Project	<b>IEEE 802.16 Broadband Wireless Access Working Group</b> < <a href="http://ieee802.org/16">http://ieee802.org/16</a> >	
Title	<b>MBS_DATA_Time_Diversity_IE Corrections</b>	
Date Submitted	<b>2007-11-01</b>	
Source(s)	Lei Wang, Sina Zahedi, Yair Bourlas, Wee Peng Goh  NextWave Broadband	Voice: [Telephone Number (optional)] E-mail: <a href="mailto:lwang@nextwave.com">lwang@nextwave.com</a> ; <a href="mailto:ybourlas@nextwave.com">ybourlas@nextwave.com</a> ; <a href="mailto:wgoh@nextwave.com">wgoh@nextwave.com</a> ; <a href="mailto:szahedi@nextwave.com">szahedi@nextwave.com</a>  * <a href="http://standards.ieee.org/faqs/affiliationFAQ.html">http://standards.ieee.org/faqs/affiliationFAQ.html</a> >
Re:	802.16 Working Group Letter Ballot #26	
Abstract	This document proposes fixes in MBS_DATA_Time_Diversity_IE.	
Purpose	To be discussed and adopted by 802.16 Rev2.	
Notice	<i>This document does not represent the agreed views of the IEEE 802.16 Working Group or any of its subgroups. It represents only the views of the participants listed in the "Source(s)" field above. It is offered as a basis for discussion. It is not binding on the contributor(s), who reserve(s) the right to add,

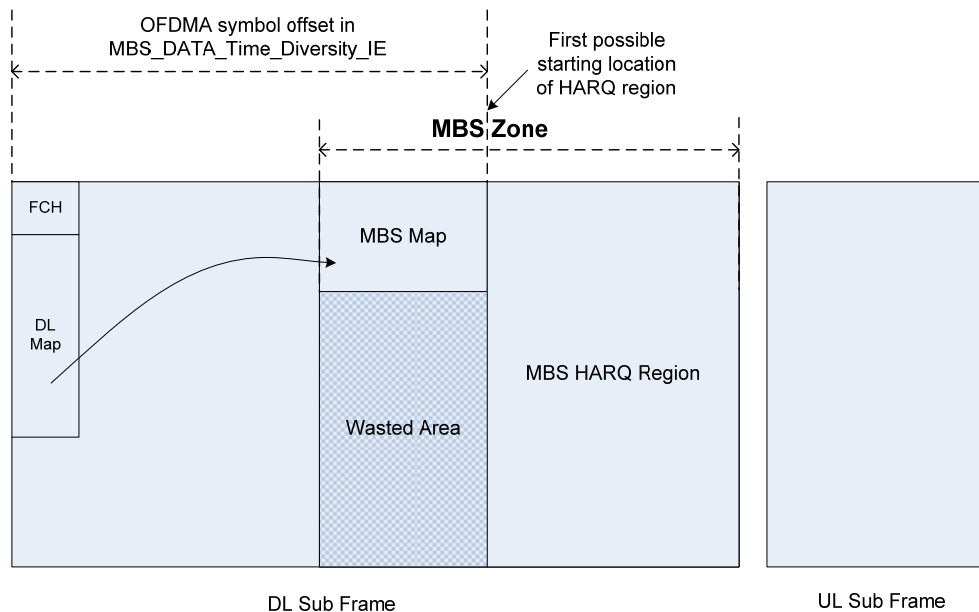
- 1) in Rev2/D1, page 267, Table 182, the field “# of MBS\_DATA\_Time\_Diversity IEs with the same MBS Burst Frame Offset” is incorrect, as it is not the number of the diversity IE itself, it is actually the number of MBS HARQ data sub-bursts;
- 2) The field “OFDMA symbol offset” in MBS\_DATA\_Time\_Diversity IE indicates the starting offset of the MBS HARQ region, and the MBS HARQ region defined by the MBS\_DATA\_Time\_Diversity\_IE spans over the entire set of subchannels. As a result, the OFDMA symbol offset of the starting location of the HARQ region need to point to a symbol after the last symbol occupying the MBS map. Using this method, the area under the MBS map remains unused. Note that the MBS MAP allocation is specified as a block allocation by the MBS MAP IE in the DL MAP. Depending on the shape of MBS MAP allocation, such a waste could be serious as shown in the figure below.

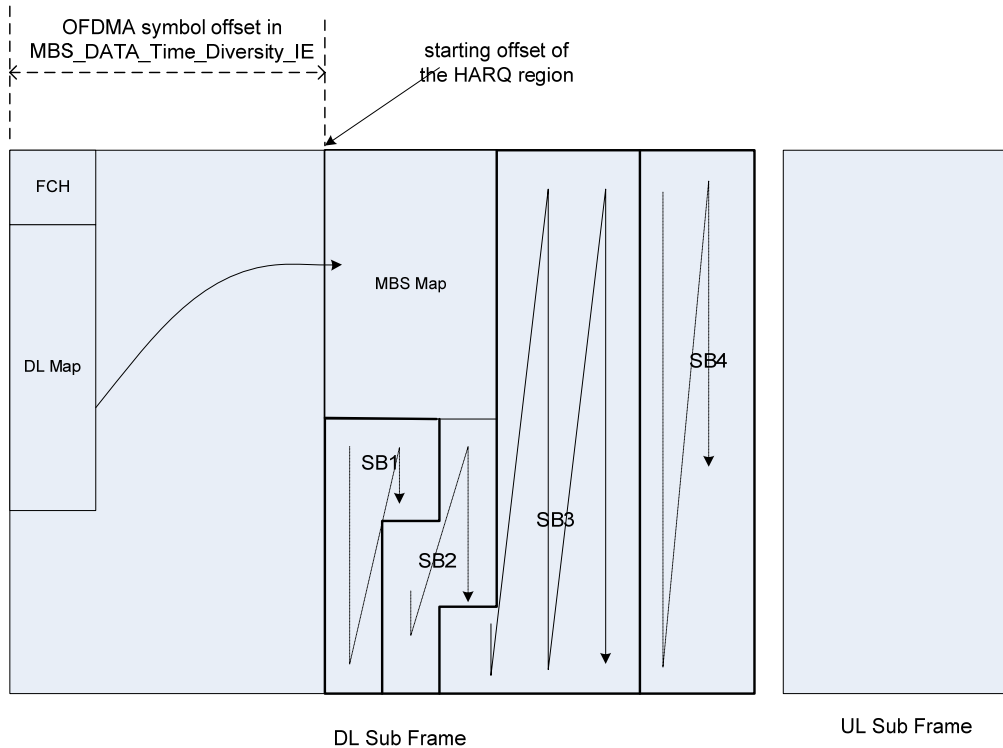
- 1) in Rev2/D1, page 267, Table 182, change the field name “# of MBS\_DATA\_Time\_Diversity IEs with the same MBS Burst Frame Offset” to “# of MBS HARQ Data sub-bursts”;
- 2) change the interpretation of MBS HARQ region defined by the parameter “OFDMA symbol

offset” so that the full MBS region can be utilized: first to allow the HARQ region to start at the same time as the MBS MAP in the same MBS zone if there are subchannels remains unoccupied by the MBS MAP; then allow MBS HARQ data sub-bursts in this region start right after the MBS MAP, i.e., at the subchannel logically numbered after the largest subchannel occupied by the MBS map and will continue in that manner until all symbol groups in the MBS map are full, as shown in the figure below.
